STAFF RECOMMENDATION
1322 6th Avenue North
April 20, 2016

Application: New construction – infill
District: Germantown Historic Preservation Zoning Overlay
Council District: 19
Map and Parcel Number: 08209005400
Applicant: Patrick Bales, Architect
Project Lead: Sean Alexander, sean.alexander@nashville.gov

Description of Project: The applicant is proposing to construct a new one-story commercial building on vacant land between two historic buildings.

① SITE PLAN
1" = 30'-0"

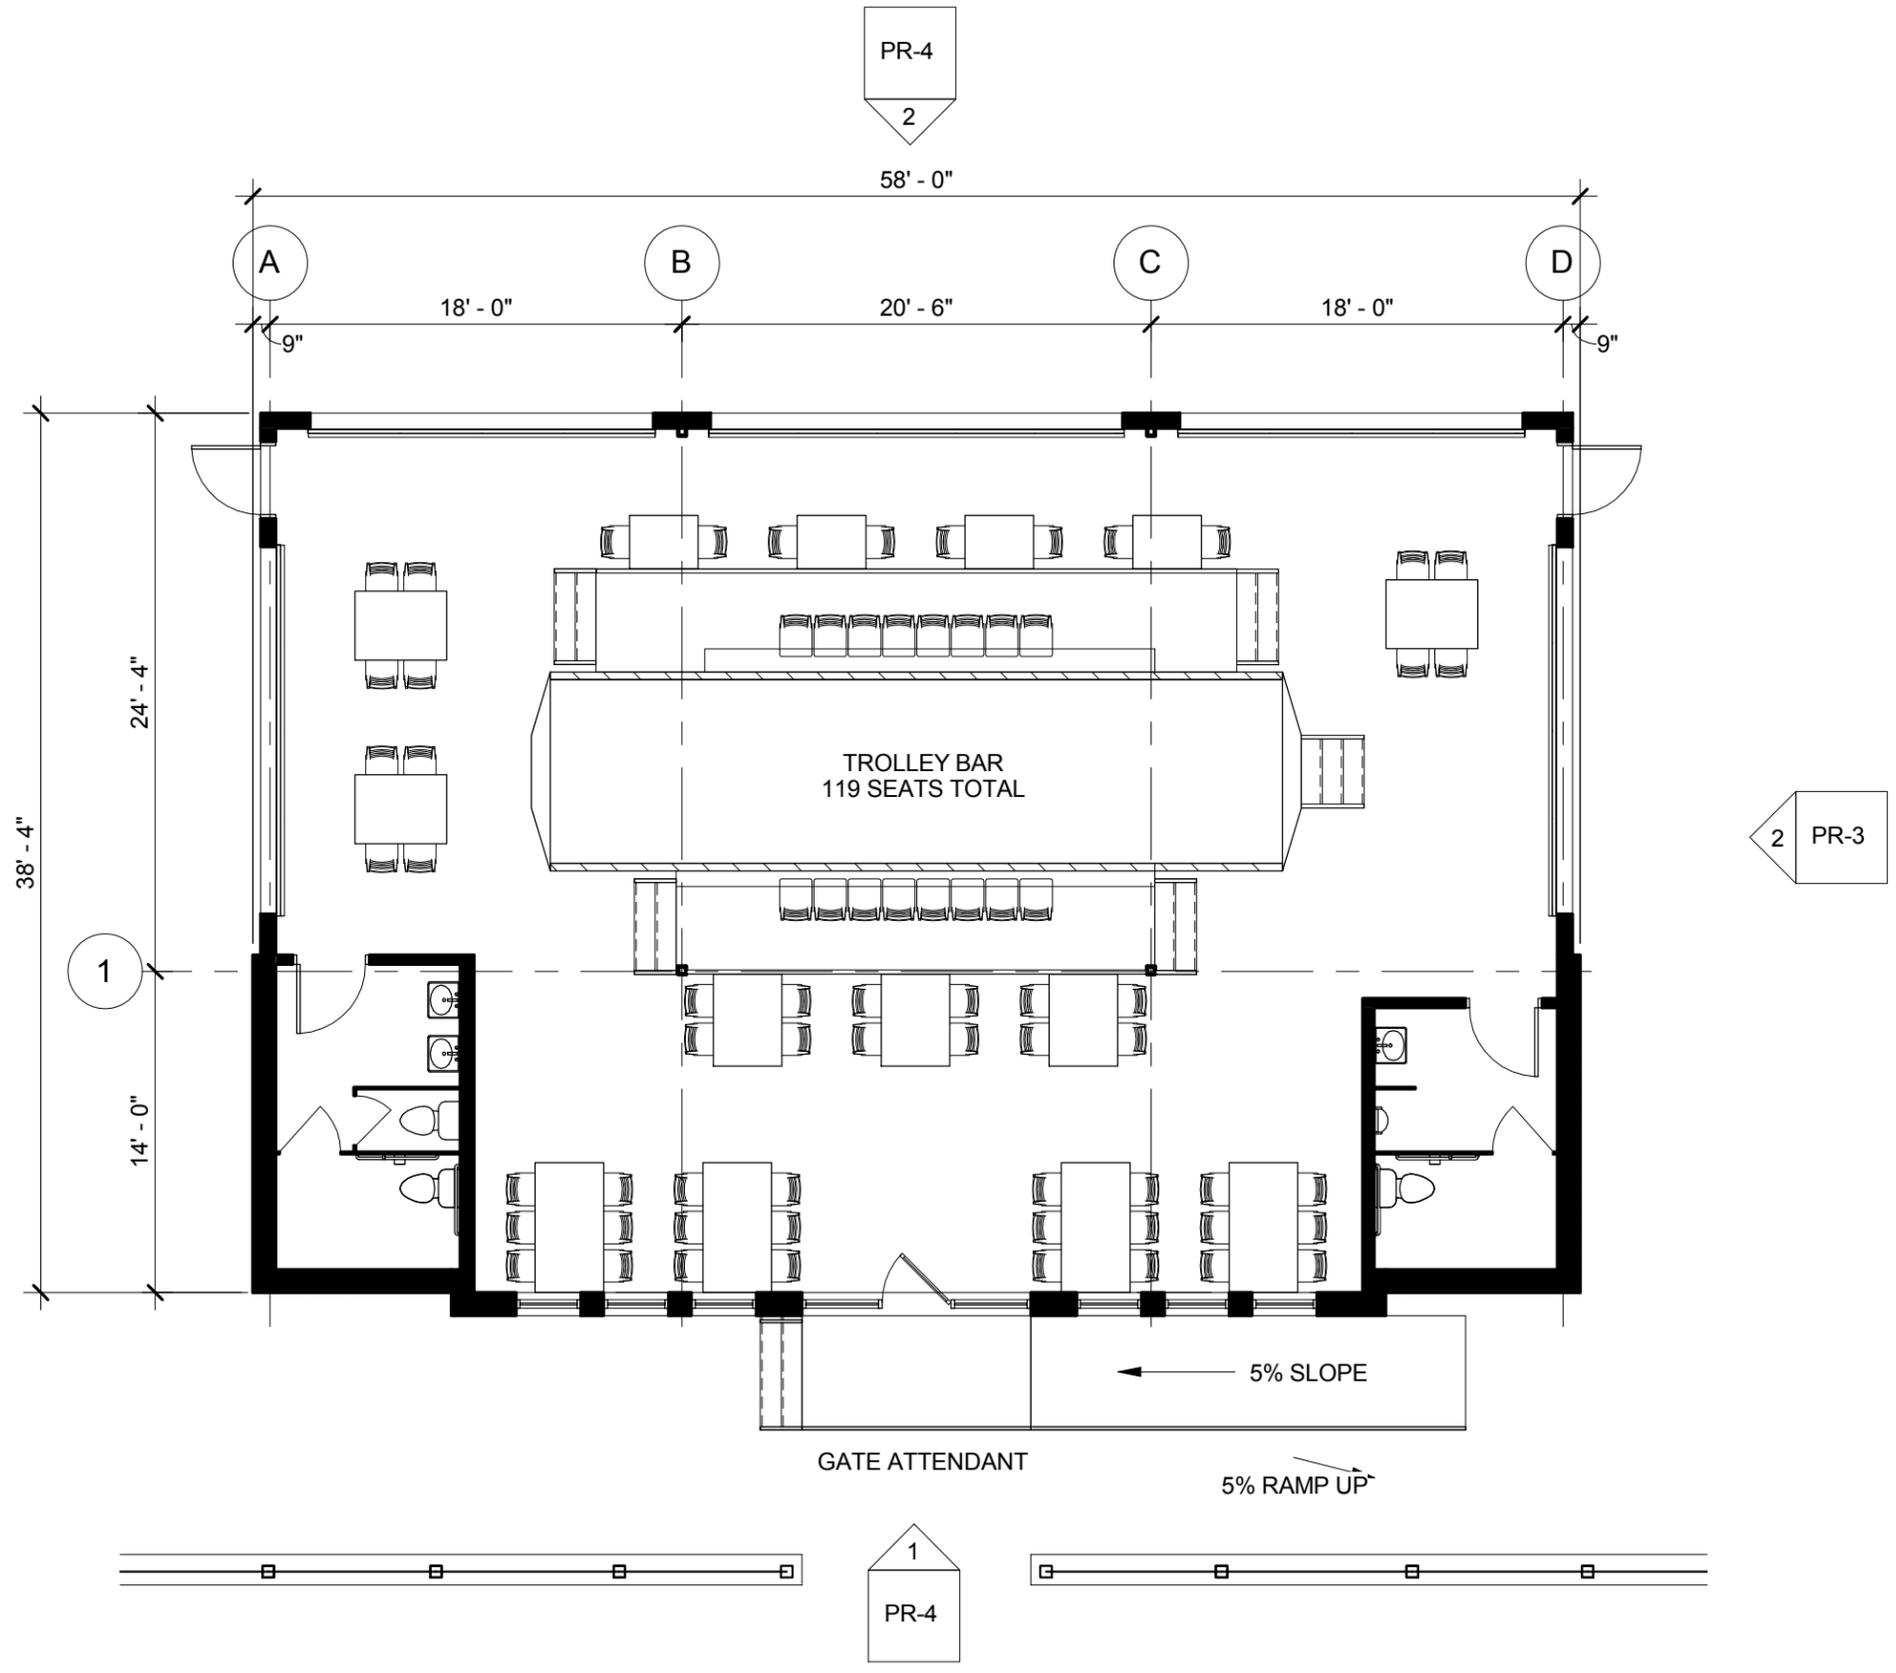
Setbacks, Orientation: The new building will be located in a vacant lot between two historic houses, with the front setback aligned between the two buildings. The new building will be centered in the space between the two existing houses, with twenty feet (20') of separation on both sides, which is compatible with the spacing between buildings historically. Staff finds that this location meets guidelines 2.2.1.1 and 2.2.1.2, which states that buildings should maintain the prevailing street setbacks and rhythm of spacing on an established block. The building will face the street directly, which staff finds to meet guidelines 2.2.3.1 and 2.2.2.

Utilities/Mechanical: The location of utilities and mechanicals are not indicated on the submitted plans. Staff recommends that they be located behind the building on a non-street-facing façade, or on the roof behind the mid-point of the building in order to meet section 2.8.1 of the design guidelines.

The project will retain portions of an existing parking lot at the rear of the property, accessed by an existing driveway to the right of the building at 1318 and the alley. This lot will be shared by the new building and the two adjacent buildings, with entrances from 6th Avenue North at an existing curb cut and the alley to the rear. Staff finds the parking lot design to meet section 5.3 of the design guidelines.

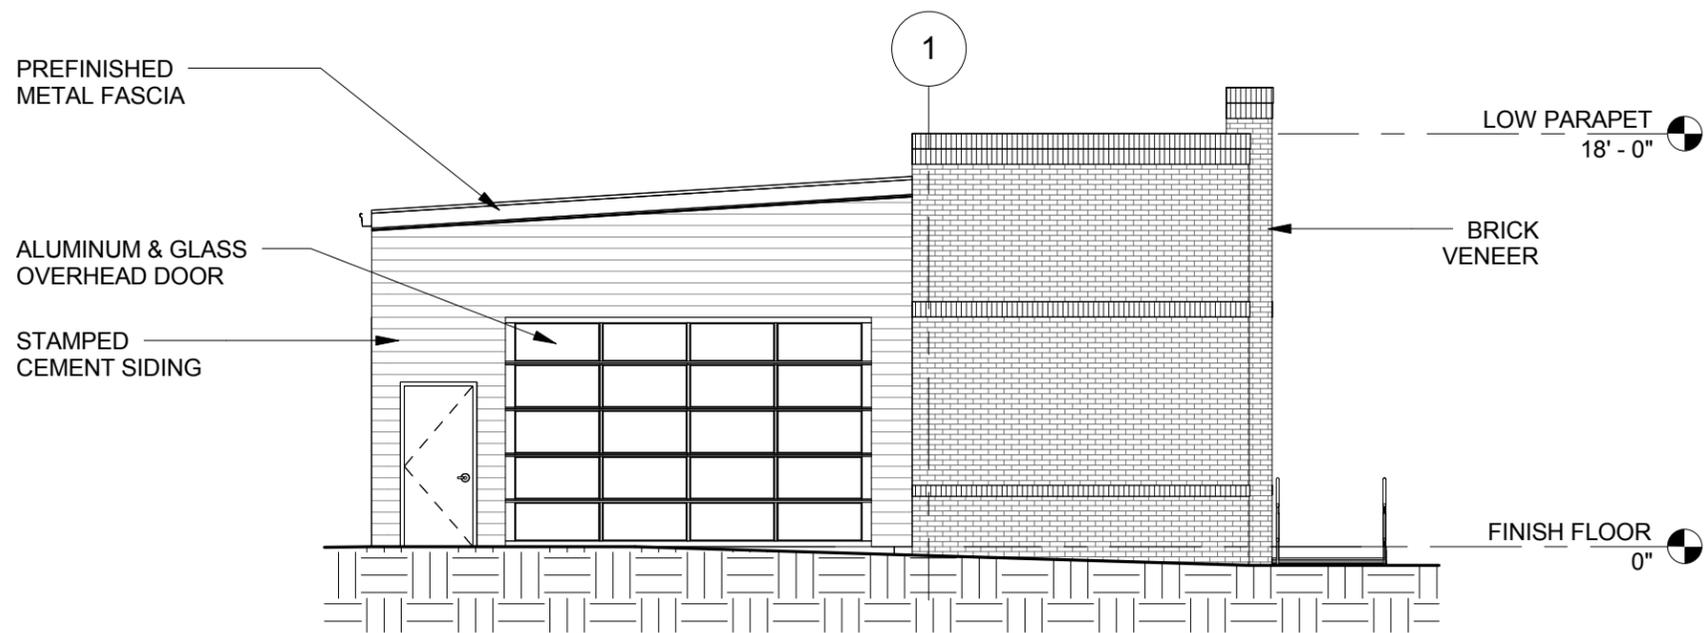
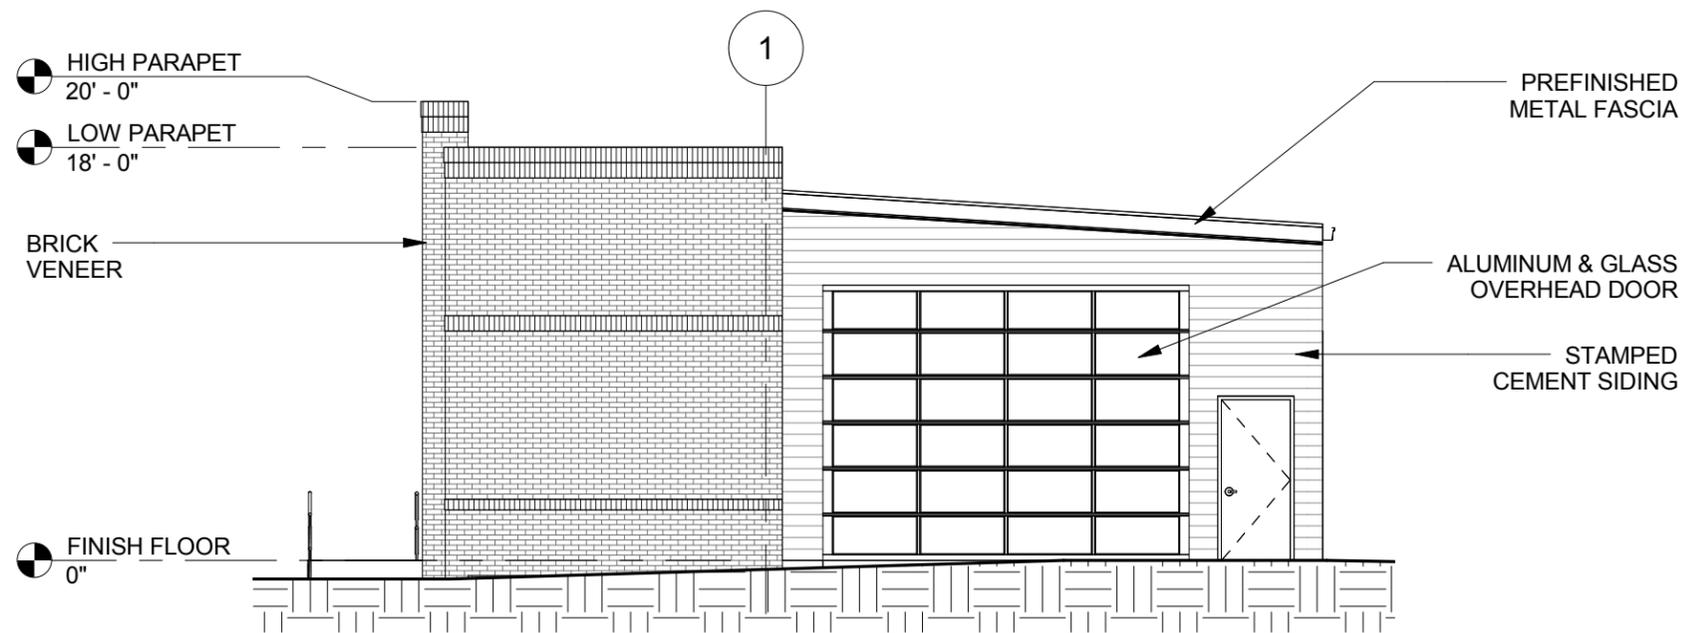
Walls/Exterior Materials: The primary exterior materials on the new building will include brick on the front façade, continuing on the sides approximately one third of the depth of the building before switching to cement-fiber clapboard siding. Both of these materials are appropriate for new construction when the brick is traditional in its color and texture, and the cement-fiber siding has a smooth surface with an exposure no greater than five inches (5"). Staff also asks that any exposed corner between two clapboard-sided walls have a four inch cornerboards, as is typical of historic buildings. With the conditions that Staff shall approve the masonry and siding selections and that cornerboards are added, Staff finds that the infill meets guidelines 2.4.1, 2.4.5, and 2.4.6.

The side and rear elevations will have overhead doors. The doors on the rear cannot be seen from 6th Avenue North, and therefore do not have an impact on the historic character of the area. While overhead doors are not typical of side facades historically, Staff finds the doors in this location to be appropriate because they are behind the midpoint of the building walls that are clad with a secondary material, and Germantown historically had industrial buildings that included rollup doors on non-primary facades. Staff asks to approve the specific window and door selections prior to purchase and installation. With

- Staff shall approve the masonry and siding selections prior to purchase and installation,
- Cornerboards shall be added at the exposed intersection of clapboard walls
- Window and door selections are approved by Staff prior to purchase and installation
- Utilities shall be located behind the mid-point of the building

① FRONT ELEVATION
1/8" = 1'-0"

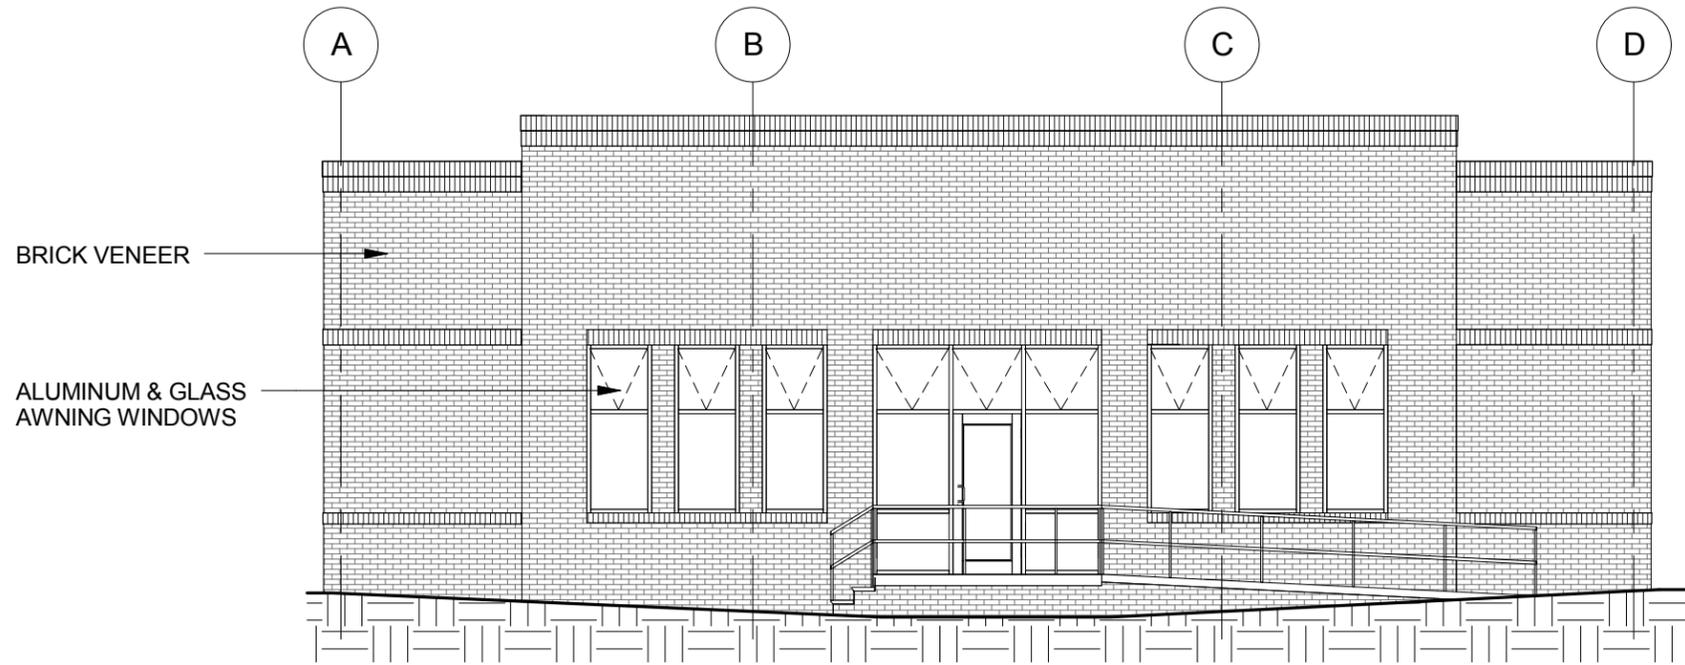
Mass and Scale, Height: The new building will be one story, twenty feet (20') tall from grade to the top of a parapet on the front façade. Both of the adjacent historic houses are twenty feet (20') tall as well. Staff finds the proposed new building to meet guideline 2.2.4.1, which states that buildings shall be compatible with the heights of adjacent buildings.

The front facade of the new building will be symmetrical with five distinct bays. In the center of the building will be a main entrance, with a trio of windows in the bays to either side. Together these three bays will be forty feet (40') wide. This center section of the building will be flanked by a pair of shorter windowless walls, set one foot (1') back from the front wall. These bays will bring the total width of the building to fifty-eight feet (58') wide.

Windows & Doors: The front façade of the building will have a central doorway with transoms and sidelights. Staff finds the configuration and location of this primary entrance to be appropriate. The new door will be narrow and tall, will be all glass, and will be recessed four inches (4") from the primary wall. The windows on the front façade will be storefront-type windows, and they will also be narrow and tall and recessed four inches (4") from the primary wall.

Roof: The roof of the building will be flat with a stepped parapet on the front facade of the building, as seen on many historic buildings in the district. Staff finds that the project will meet sections 2.7.1 and 2.7.3 of the design guidelines.
